5 September 2018

**Re: Response to Review Comments
750 Walnut Avenue – Block 541, Lot 2
Township of Cranford, Union County, New Jersey
Langan Project No.: 130102501**

Drawing No.
FIGURE 1
 Sheet 1 of 1

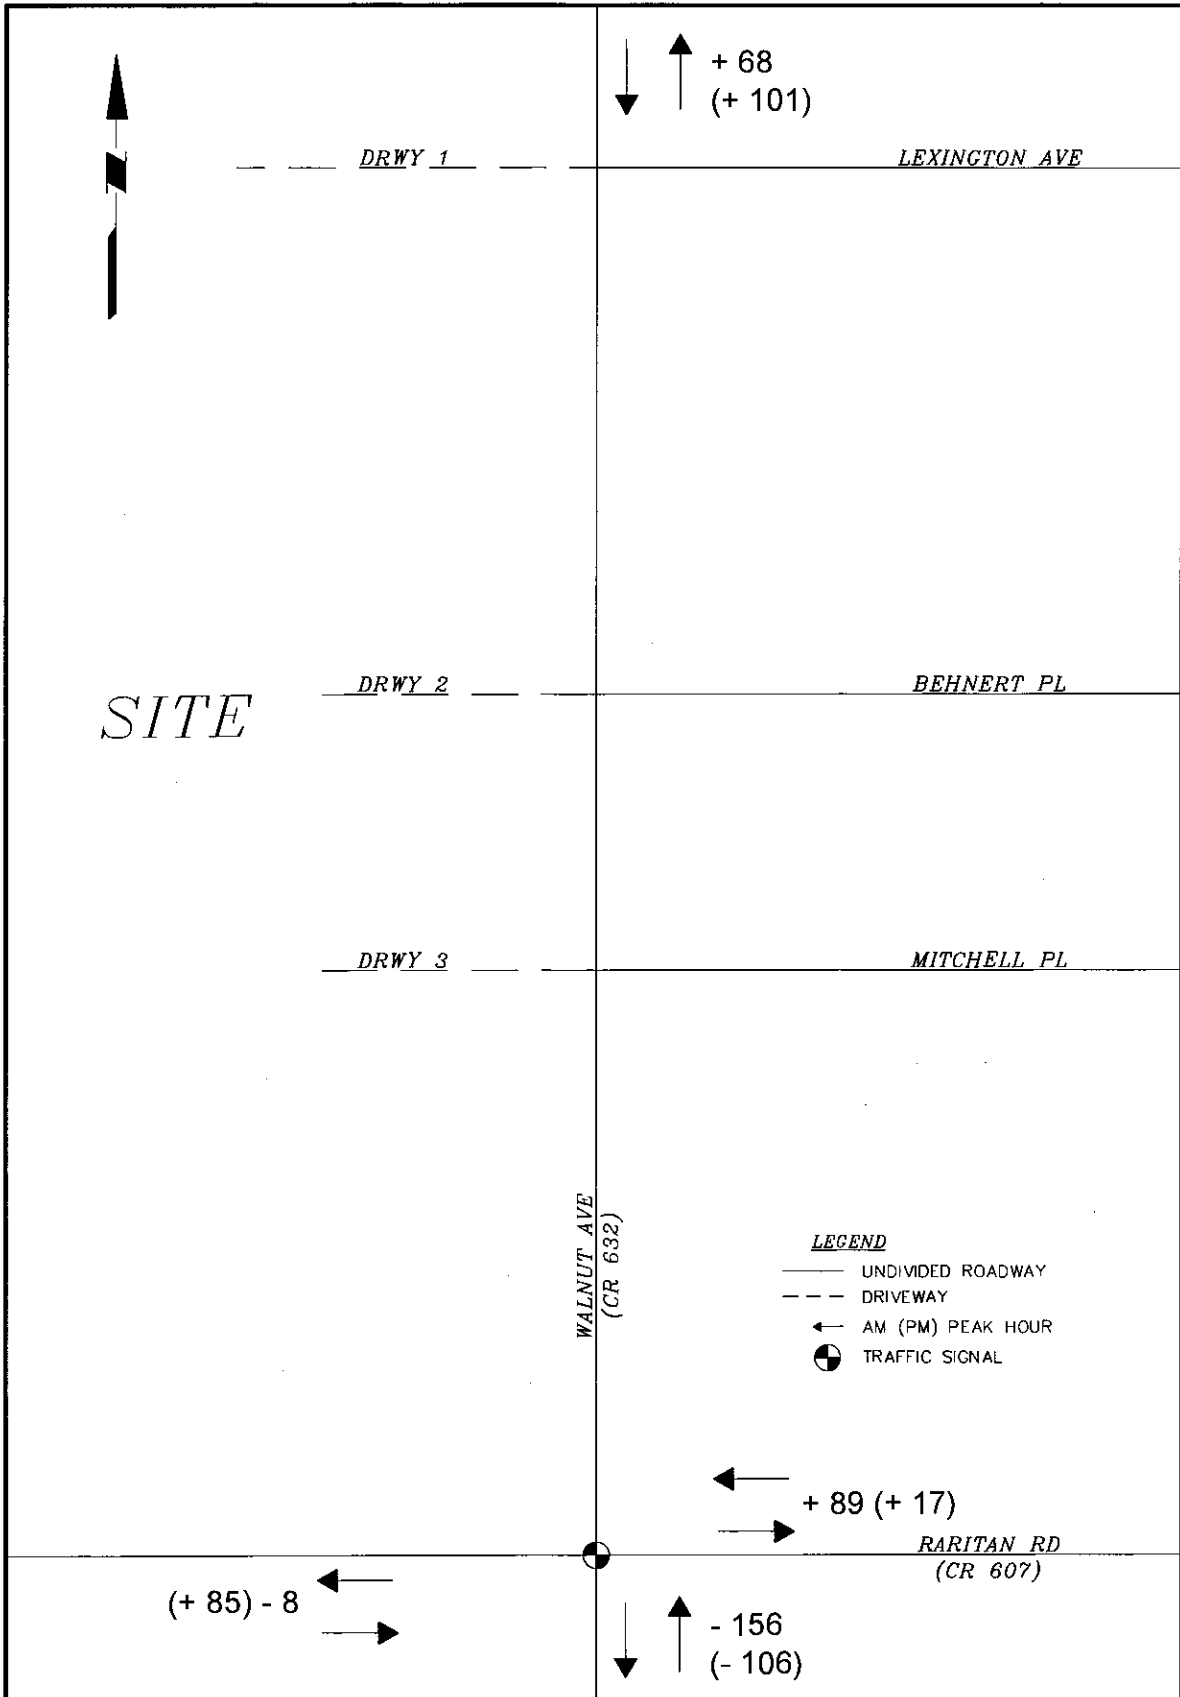
6. Based upon the trip generation estimates in the Traffic Impact Study, there are over 100 trips generated by the project site south of the intersection of Walnut Avenue & Raritan Road and north of the intersection of Walnut Avenue & Lexington Avenue. Testimony or an evaluation should be provided to confirm the study area is adequate to assess the traffic impact of the proposed development.

The projected net change of new trips based on redevelopment of the property with the residential community as compared to the traffic that would exist with full re-occupancy of the existing office/industrial buildings is generally below 100 trips in both directions along the roadway sections north and south of the project site with the exception of the PM Peak Highway Hour where just over 100 two way trips are calculated north of the site. While the roadways are not under state jurisdiction, the NJDOT generally sets the need for a road section or intersection to be studied if it is significantly impacted, which is defined as a change of use that generates the addition of 100 or more peak hour trips. The net change is shown in the table below which is the difference between the full occupancy of the existing development with re-occupancy by an office tenant and full buildout of the proposed development. It is noted that the difference would be significantly less if the existing building were re-occupied by permitted medical office uses. Figure 1 shows the net change by direction.

We believe that for the purpose of the zoning analyses, the study locations included are appropriate and provide sufficient information for purposes of understanding the relevant impacts of traffic generated by development of the property under existing zoning versus with the proposed residential uses. At the time of site plan approval, further study would be conducted to identify specific access geometry, traffic control and traffic mitigation.
